ADDENDUM 5

DATE: 05/25/22

'Matilda Torres High School, Toros Stadium'
Matilda Torres High School
16645 Road 26. Madera, CA 93638

DARDEN PROJECT NO. 0622.4
DSA File Nos. 10-C3
DSA APPL. NO. 02-118396

AD5-AX01

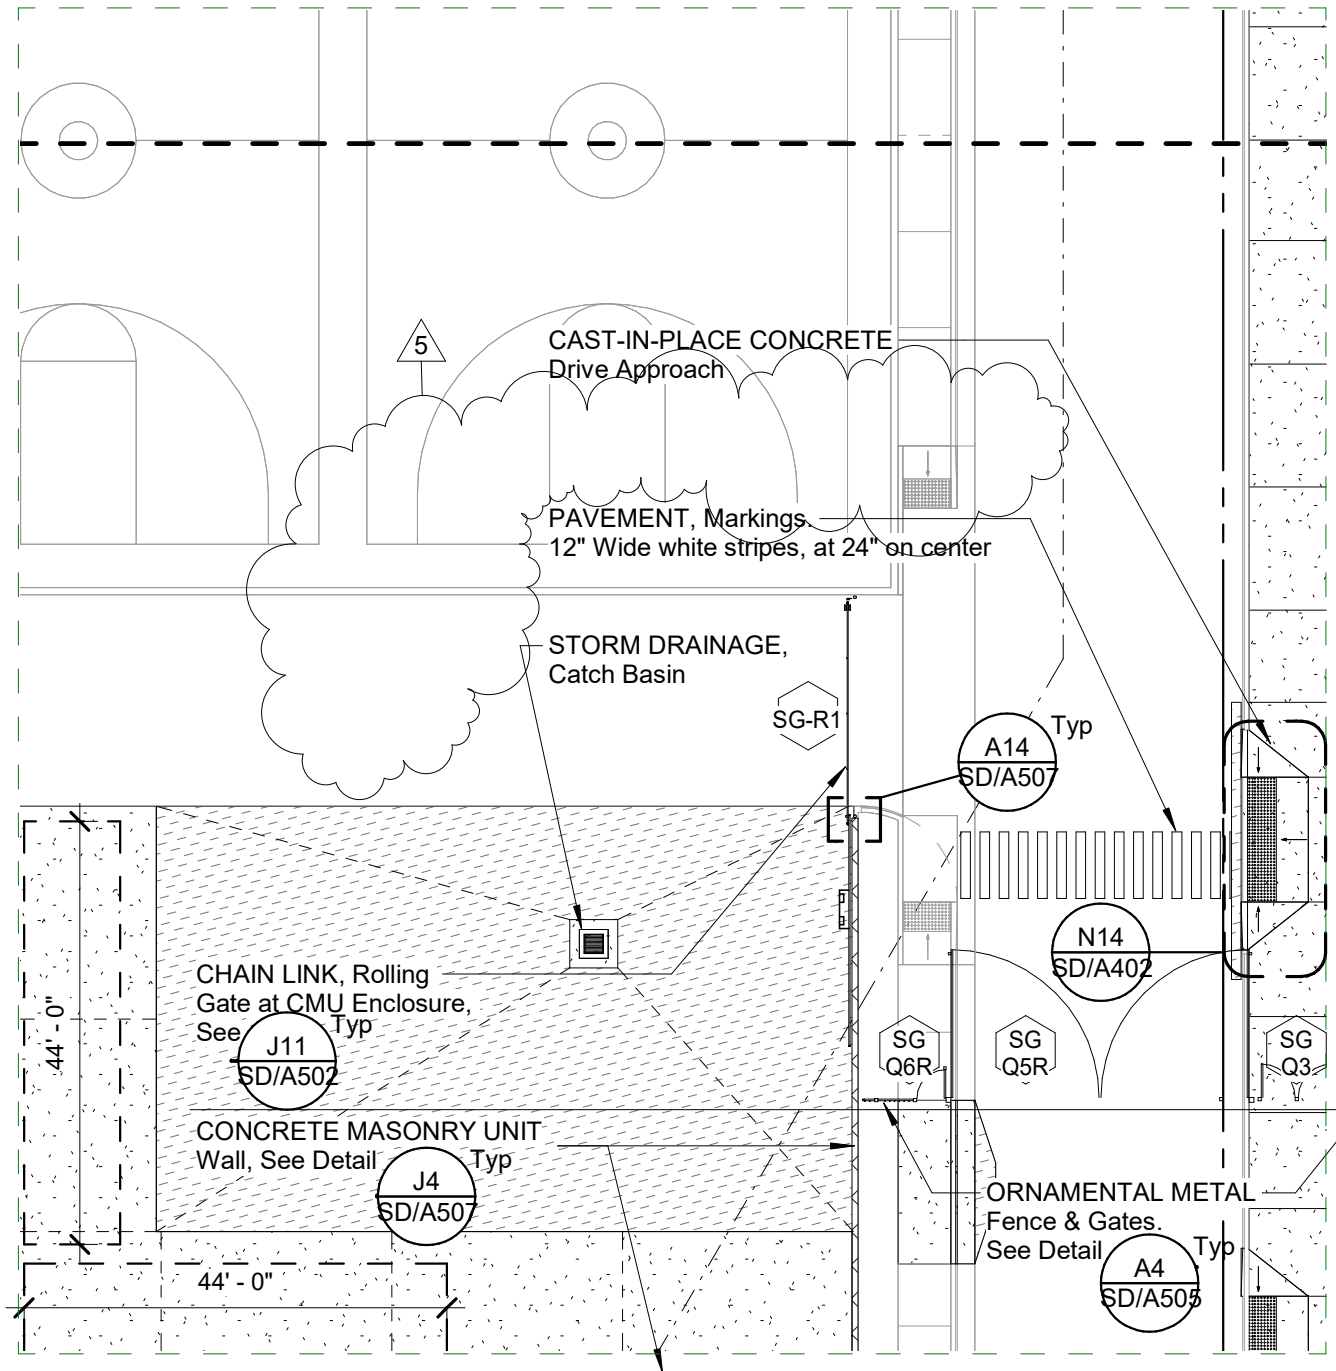
AD5-A01 Refer to Sheet X/A503

1. Replace detail A10 with attached detail AD5-AX01
 - a. plaster setting bed at cmu veneer walls clarified. All cmu veneer block walls to have cement plaster setting bed. CMU veneer **above 8'-0"** to have cement plaster setting bed **AND** masonry anchors as indicated in details J14 and E14, X/A504.
 - b. All CMU veneer to be 2 5/8" thick

A10 - X/A504

CMU face Shell Attachment at Wall Curb

AD5-AX02

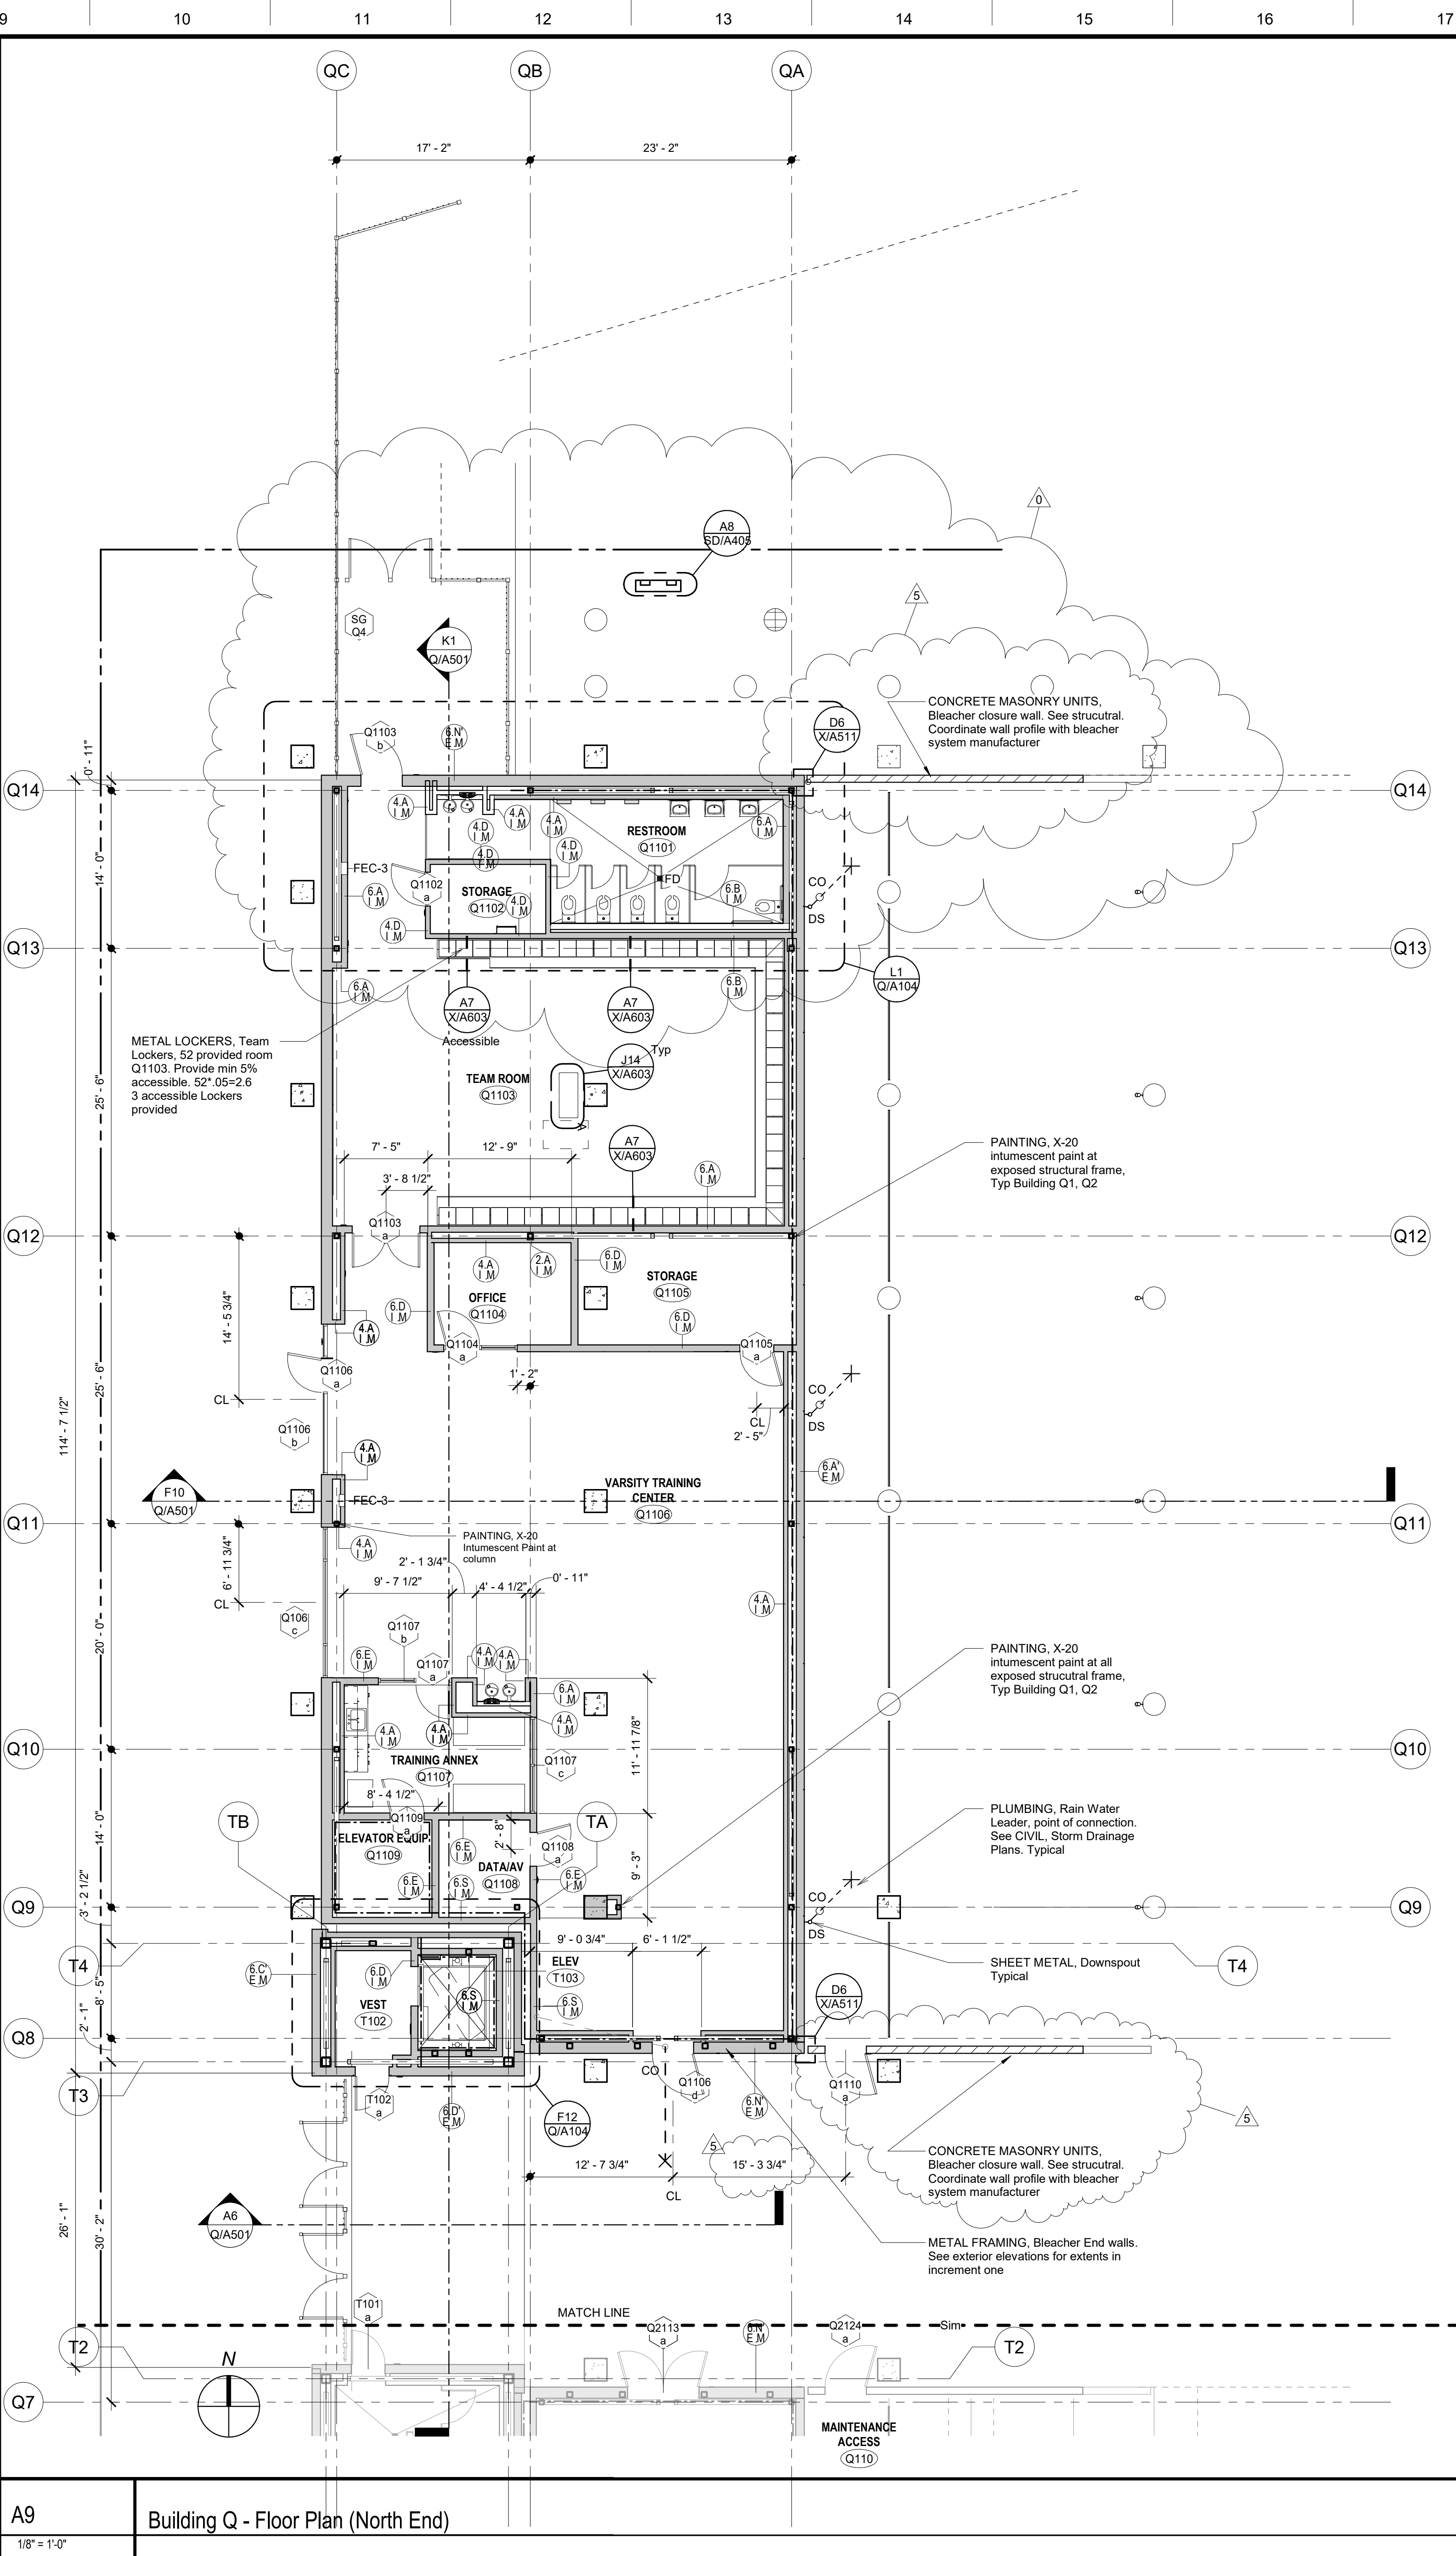
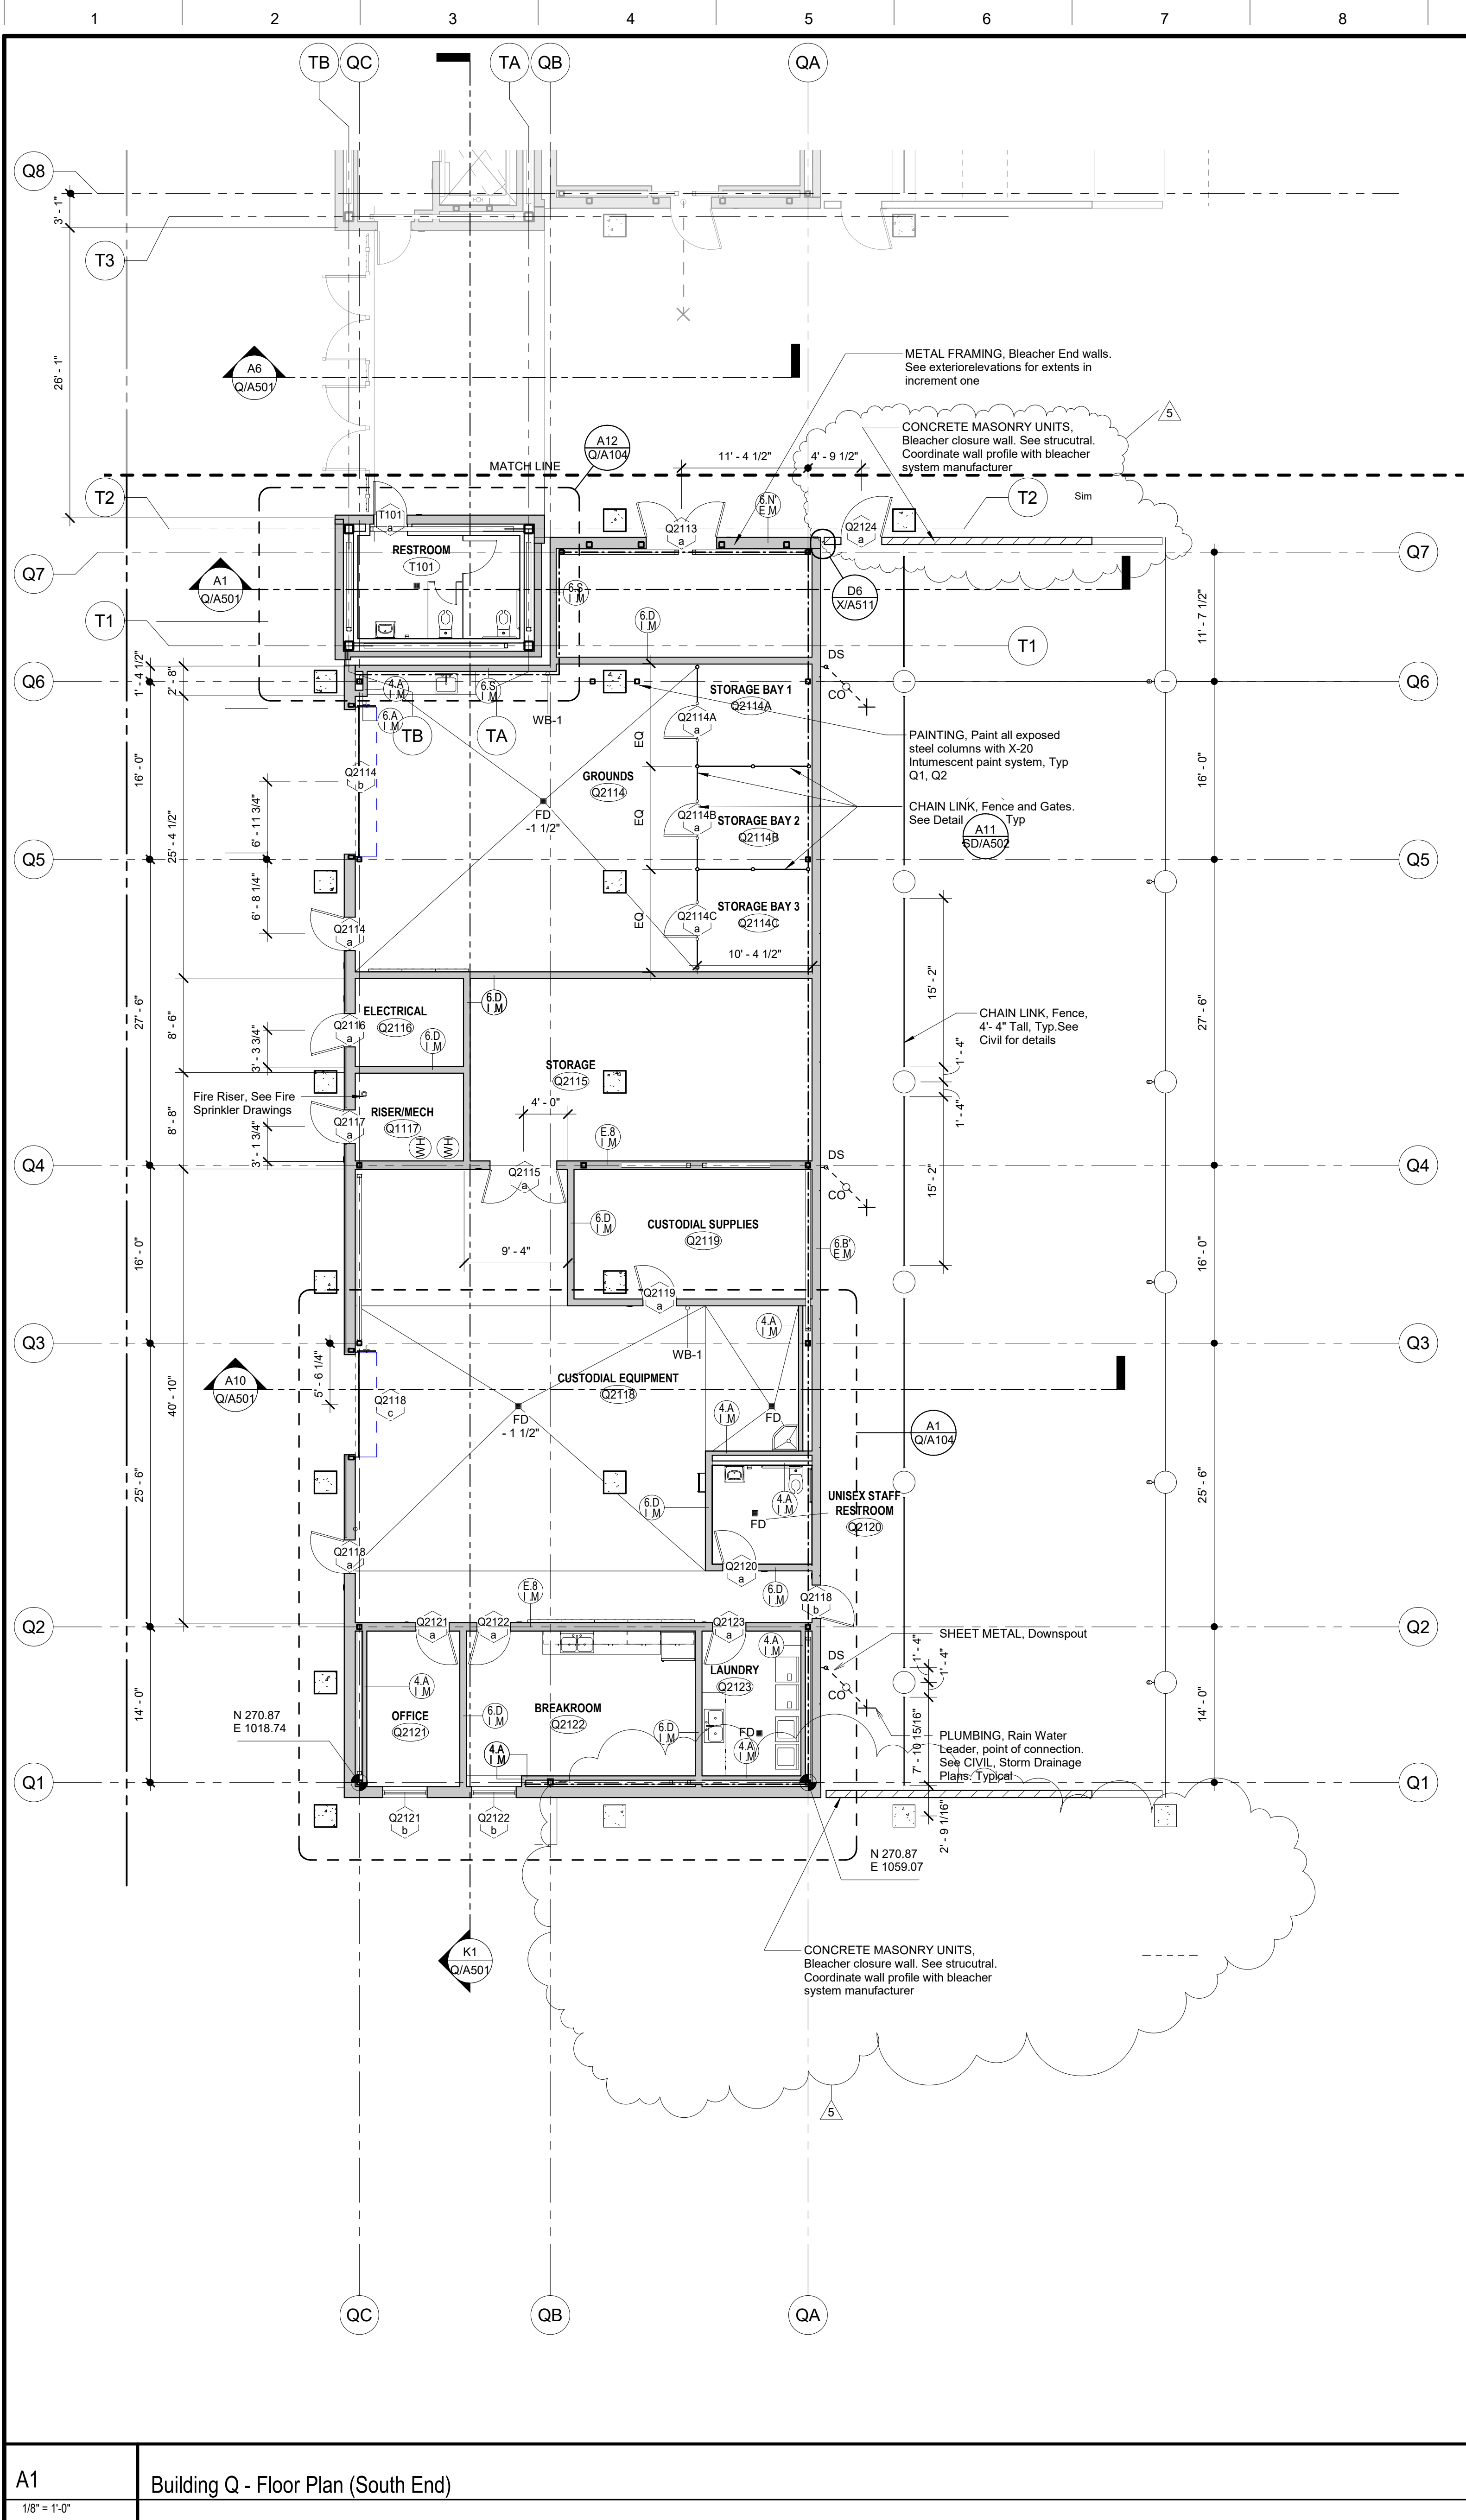
AD5-A02 Refer to Sheet SD/A206

1. Remove note reading "PAVEMENT, Parking Area Seal". As shown in attached exhibit AD5-AX02

Sheet SD/A206

Pavement seal note removed
